#### PLANNING

project title		
KOKO + Hope & Anchor + Bayham Place Camden, London		
drawing title	scale	date
Proposed Fourth Floor Plan	1:100 (A1)	13.04.17
drawing number	drawn	checked
AAH/KKC/GA/104	FR/PC	DA
	revision	
	K

#### LBC - Condition 4c

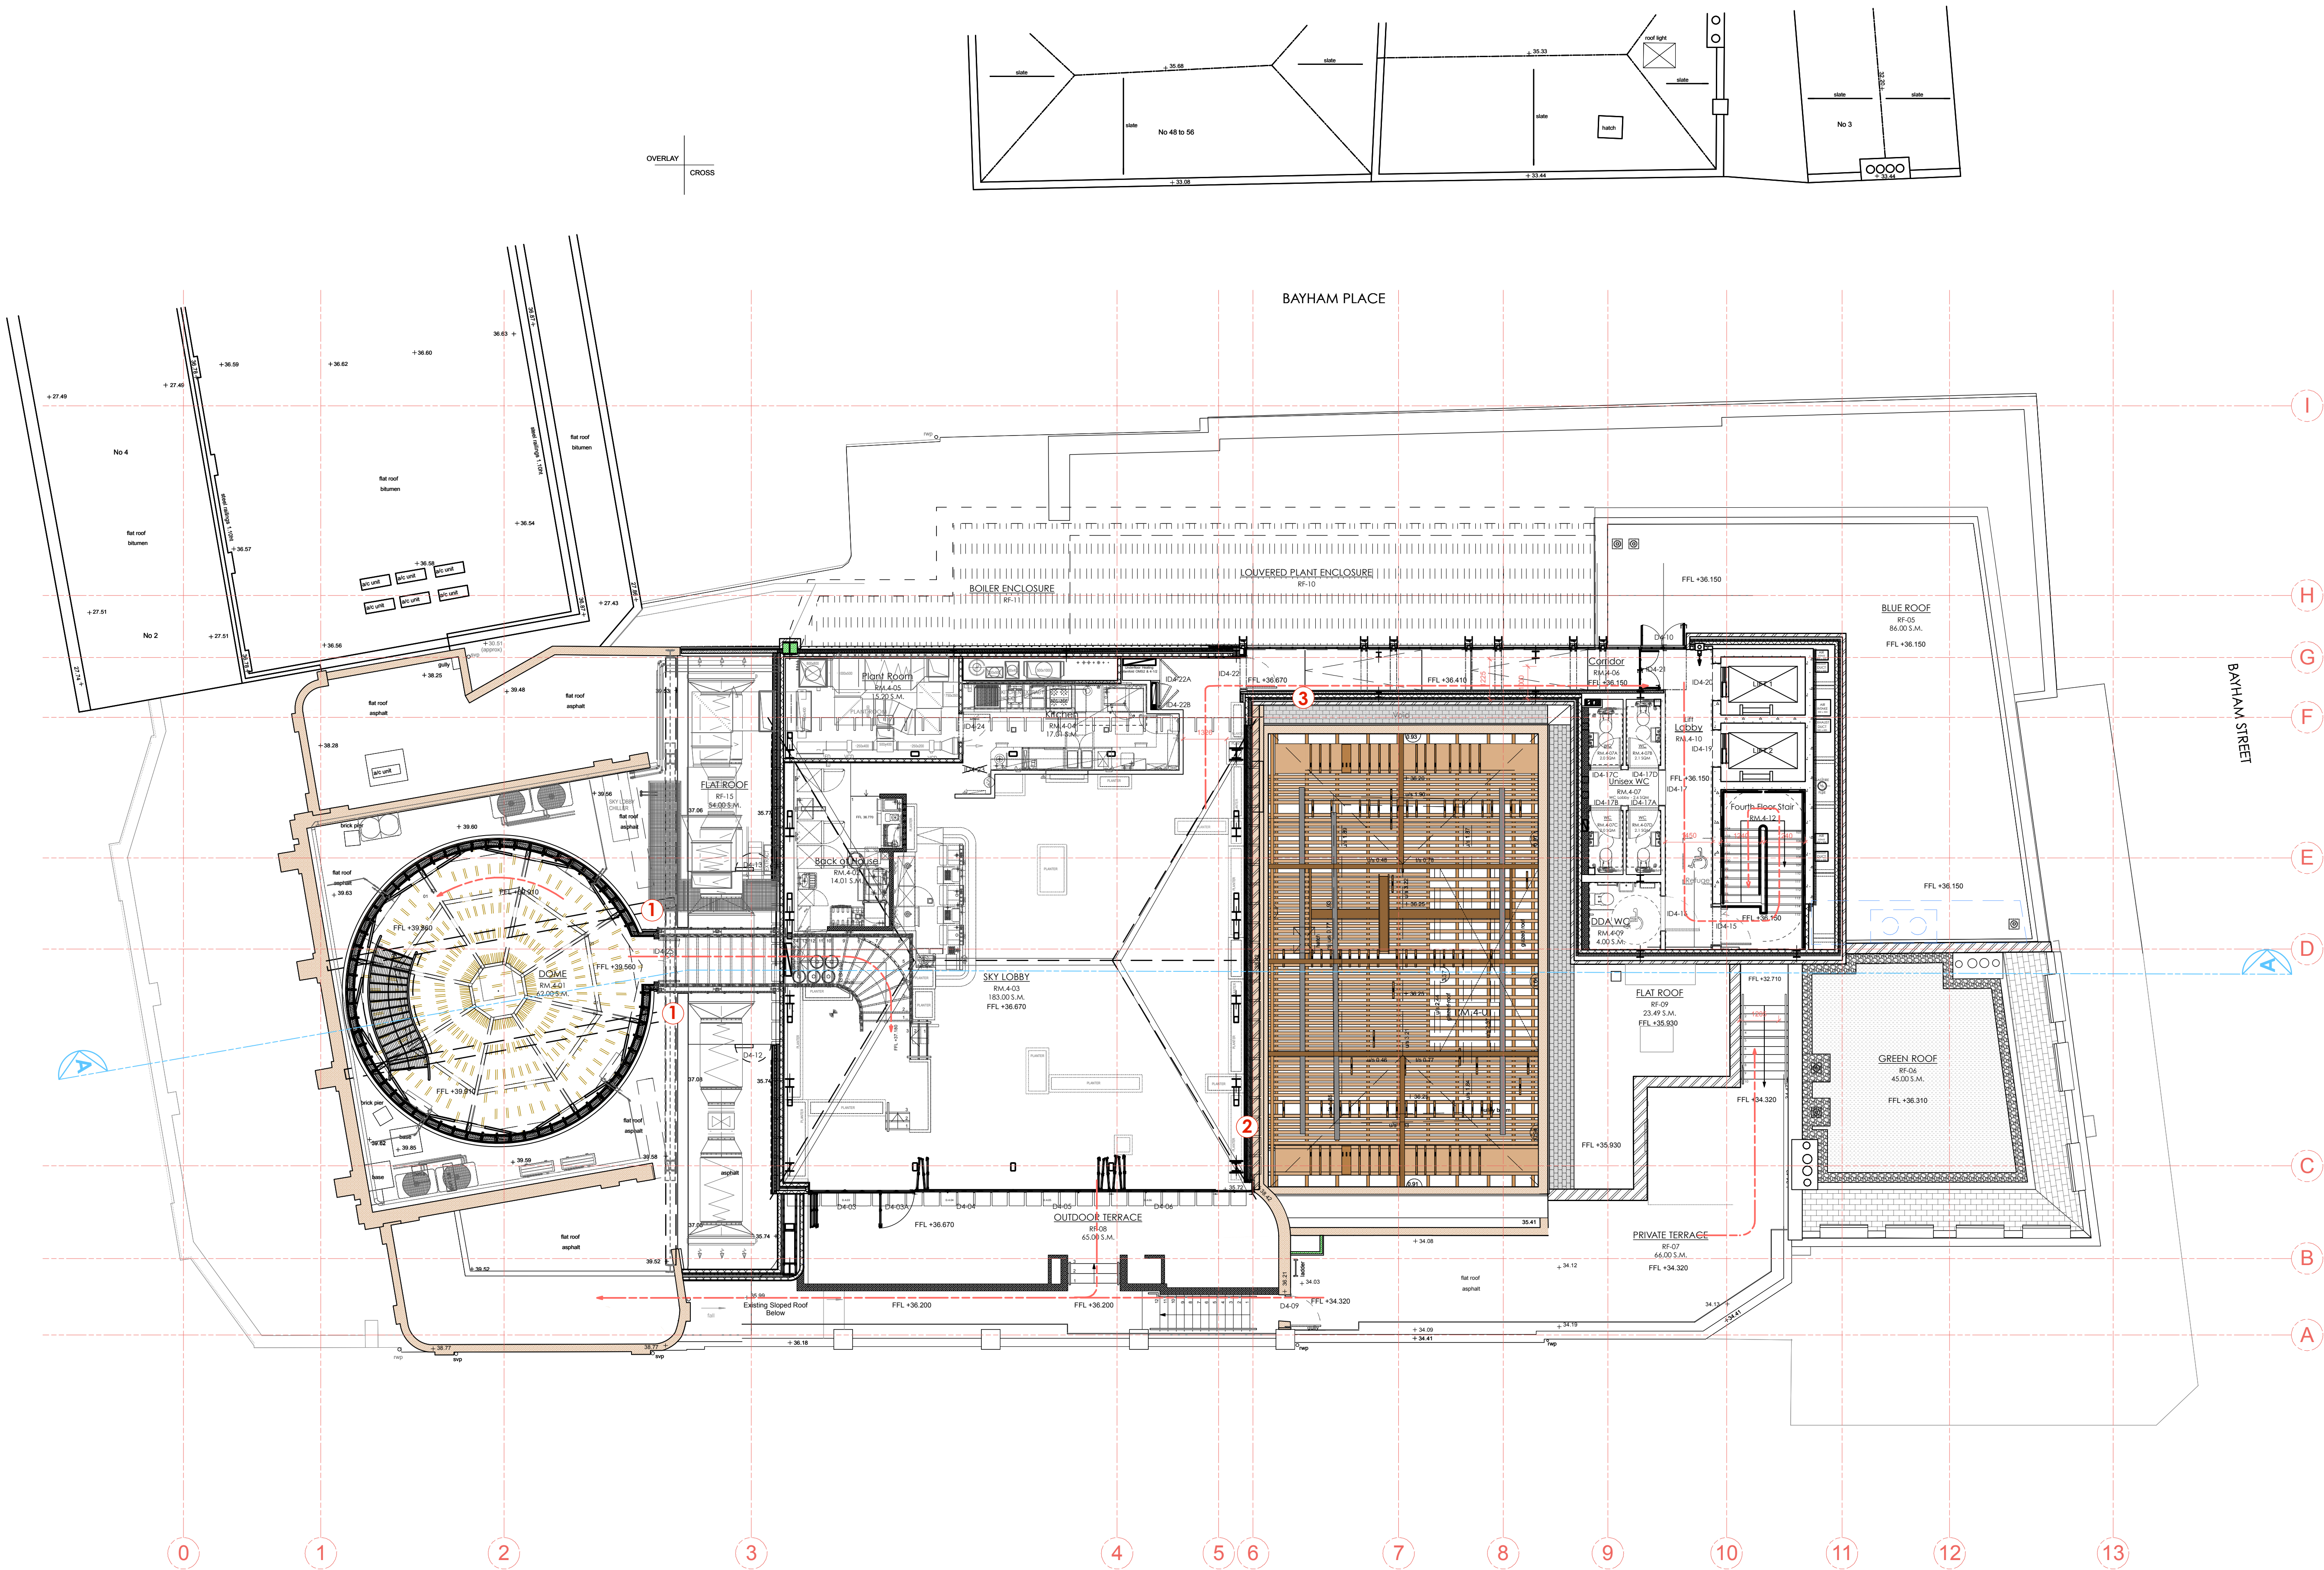
4.9. Wall depth increased to include void for services	
G / 06/08/18 /	Colour coding added to revised drawing Revf	
H / 15/08/18 /	Plan issued for Planning Application	
I / 26/03/19 /	Proposed Dome Truss LBC Application	
J / 12/07/19 /	Proposed Dome LBC Application for 1. Permanent Dome Truss.	
K / 11/02/2020	2. Dome Front Pier PFCs.	
	Retrospective planning application for:

1. Removal and reinstatement at high level H/L	
	2. Removal and reinstatement at low level L/L	
	3. Removal and reinstatement of walls	
	4. Removal of walls

5. Change to consented proposal.	
	Refer to colour coded legend and annotations 1-10.

##### 1. Link connection to Dome

##### 2. Sky Lobby and Flytower Wall Connection

##### 3. Glazed Walkway connection to Sky Lobby

Refer to AHA-KKR-DET-050 [A] Proposed Dome Details\_Rev A  
Refer to AHA-KKR-DET-052 [B] Dome Copper Cladding Details\_Rev B  
Refer to AHA-KKR-DET-053 [-] Dome Copper Cladding Details

Refer to AHA-KKC-DET-610 [C1] Proposed Glass Pavillion Details 1\_Rev C1  
Refer to AHA-KKC-DET-611 [-] Proposed Glass Pavillion Details 2  
Refer to AHA-KKC-DET-814 [C3] Fourth Floor Wall Types-5\_Rev C3

Refer to AHA-KKC-DET-633 [C1] Proposed 4th Floor Walkway Details\_Rev C1
